| Request | - | Major Site Plan Review for multiple buildings on a lot |

MAJOR SITE PLAN REVIEW
TOLEDO CITY PLAN COMMISSION
REF: SPR-32-24
DATE: September 12, 2024
TIME: 2:00 P.M.

MAJOR SITE PLAN AND ZONE CHANGE FOR: VILLAGE ON THE GREEN

SITE PLAN

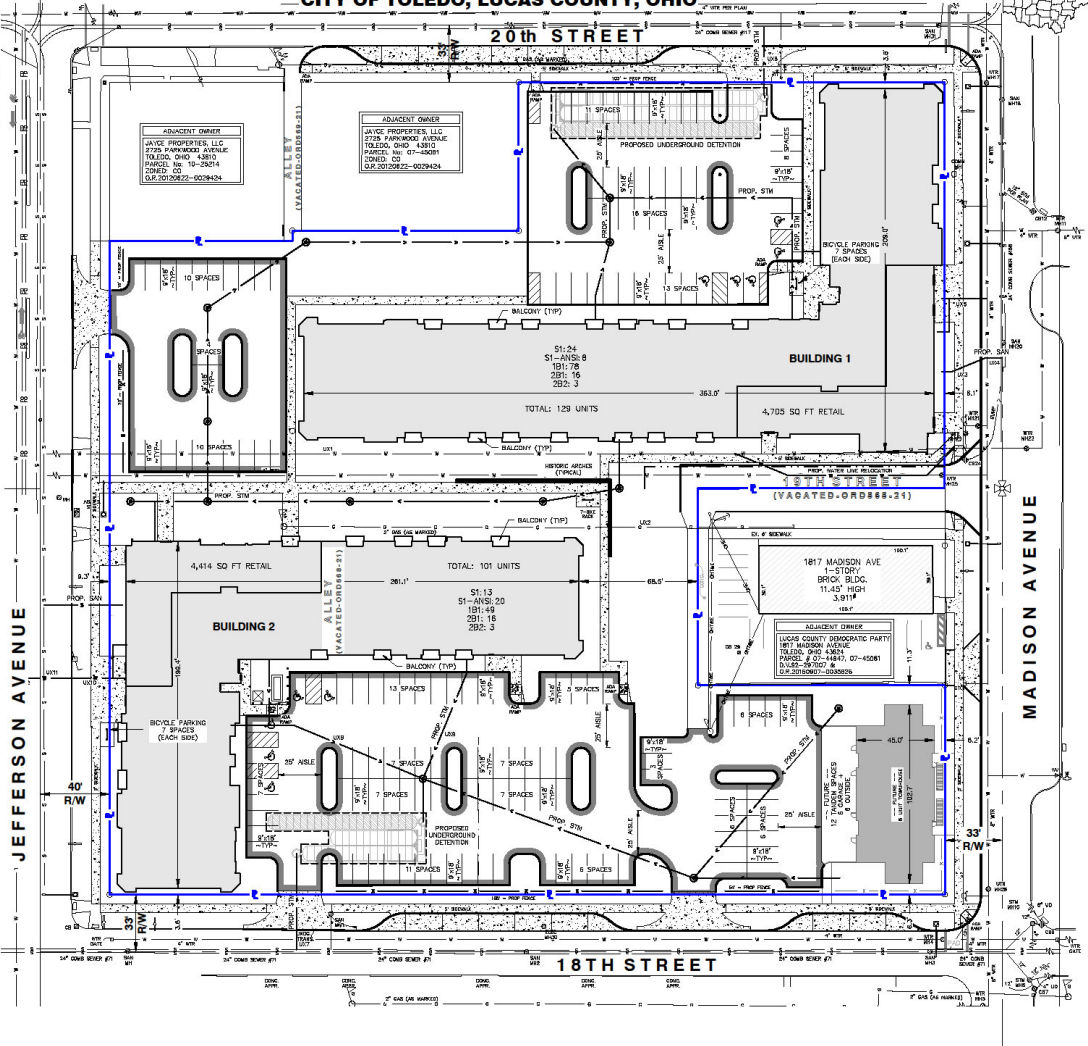
34. All spaces reserved for the use by persons with physical disabilities shall adhere to the standards outlined in TMC§1107.1700. **Not acceptable as depicted. A minimum of one (1) van accessible space shall be provided in the parking lot with access to Jefferson Street and depicted on a revised site plan.**

37. Wheel stops shall be provided per TMC§1107.1907(A). There are no wheel stops depicted on the site or landscaping plan. **Not acceptable as depicted. Wheel stops shall be provided and the site plan revised to illustrate the wheel stops.**

42. Connecting walkways must be provided for internal pedestrian circulation within the site to connect to street or place sidewalks and to connect parking spaces with the main building entrance. **Not acceptable as depicted. A sidewalk needs to be provided from 18th Street to the rear entrance of Building 2. In addition, the two sidewalks that end in parking lots shall be continued along the buildings to the rear building entrances. The site plan shall be revised to reflect the additional sidewalks.**

LANDSCAPE PLAN

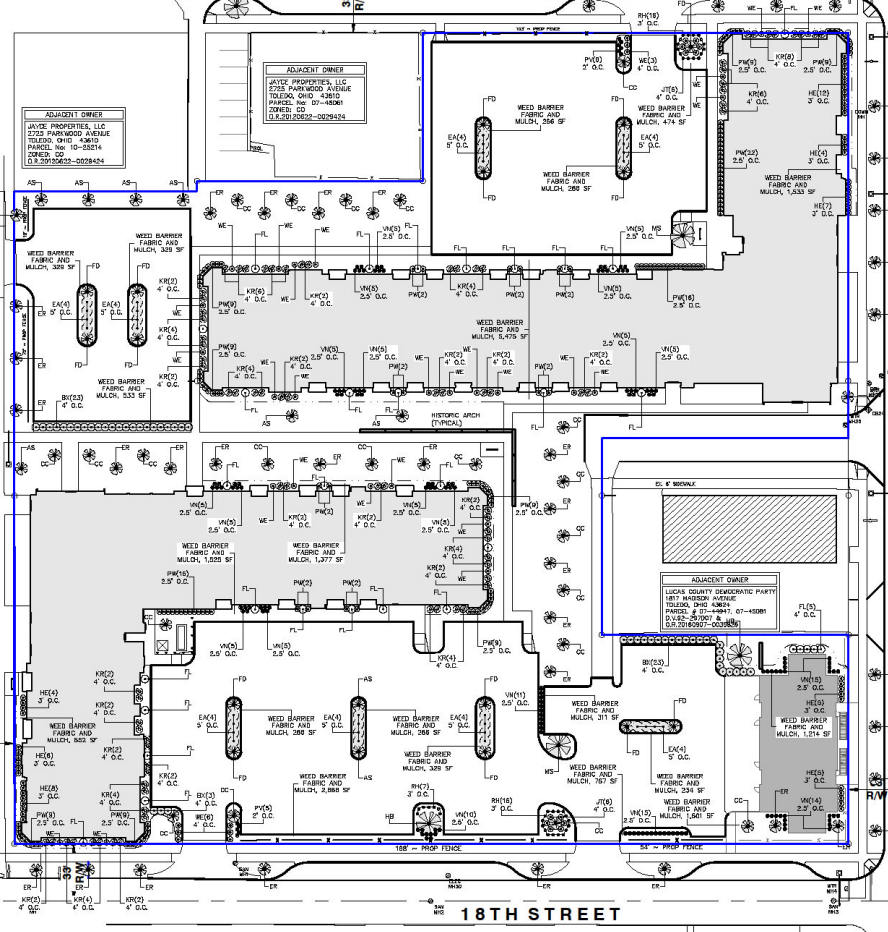
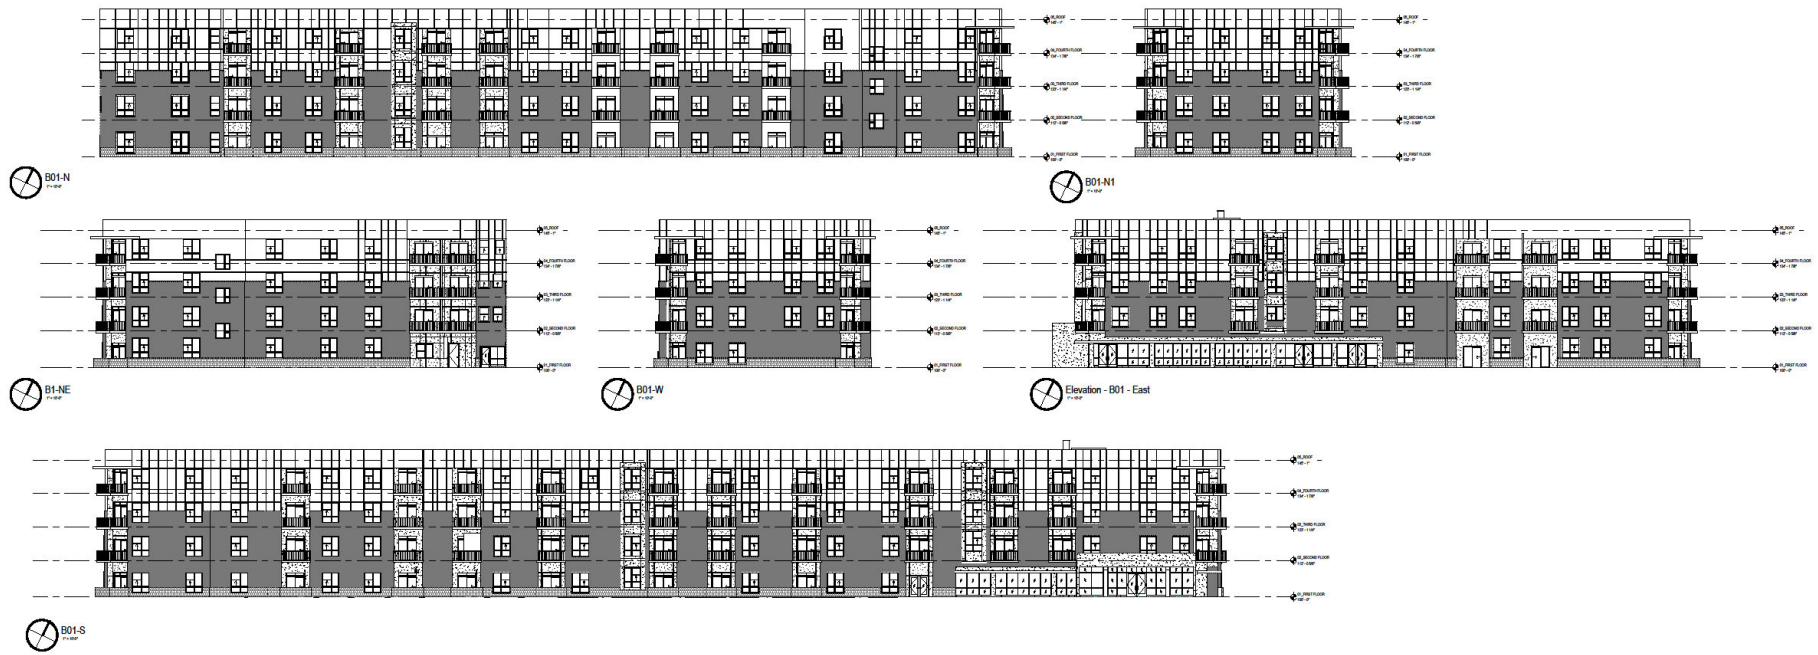
- b. Landscape improvements must also be provided in the sidewalk or other paved area in front of a building with tree grates, or other walkable surface material treatment for open tree pits, in the form of one (1) shrub or understory tree for every thirty-feet (30') of lot frontage. **Not acceptable as depicted. Trees shall be provided in front of Building 2 along Jefferson Avenue.**

- f. Pursuant to TMC§1108.0305, perimeter landscaping must be installed along any parking lot area adjacent to a street, place, or driveway. A decorative fence is depicted on the landscape plan; however, the required shrubs are not. **Not acceptable as depicted. The required shrubs shall be provided and the landscaping plan revised to illustrate the shrubs.**

- g. Since the townhomes shown on the site plan are not being reviewed at this time, the landscaping plan shall be revised to show the area where the townhomes are located as green space with a continuous row of evergreen shrubs provided along the parking lot.

ELEVATIONS - BUILDING 2

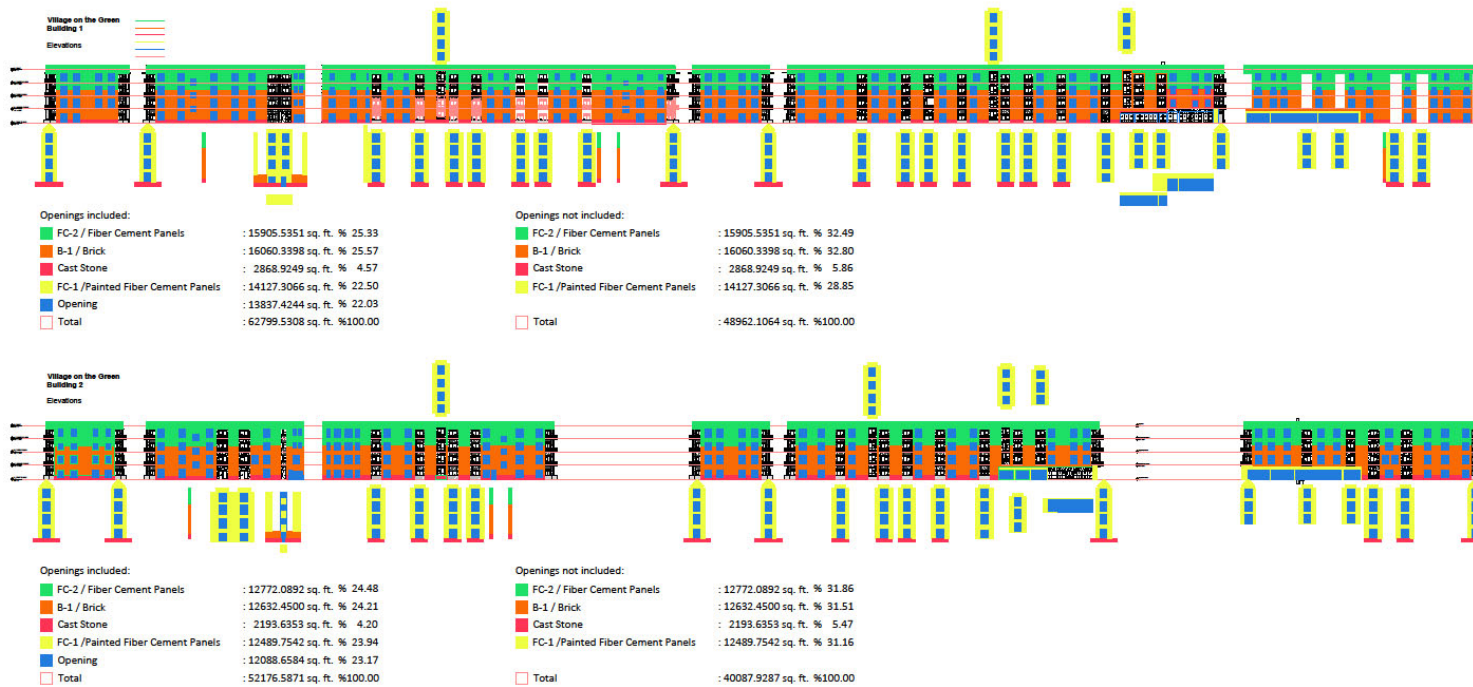
41. Building entrances must include architectural elements that emphasize the entrances per TMC§1109.0205(C)(4). All of the entrances to the buildings are difficult to distinguish and the commercial and residential entrances are indistinguishable from one another. **Not acceptable as depicted. The elevations shall be revised to include architectural elements that emphasize the entrances and distinguish the commercial and residential entrances from one another.**

45. All four (4) sides of both of the buildings shall be subject to the façade material standards as listed in TMC§1109.0500. The color palette for the building is intended to match the existing mural on the Promedica Ebeid Center building, north of the site across Madison Avenue. The materials primarily proposed on the elevations consist of brick, cast stone, fiber cement panels and glass. More than 20% of each faced includes an accent material. **Not acceptable as depicted. Revised elevations shall be submitted to illustrate compliance with material standards.**
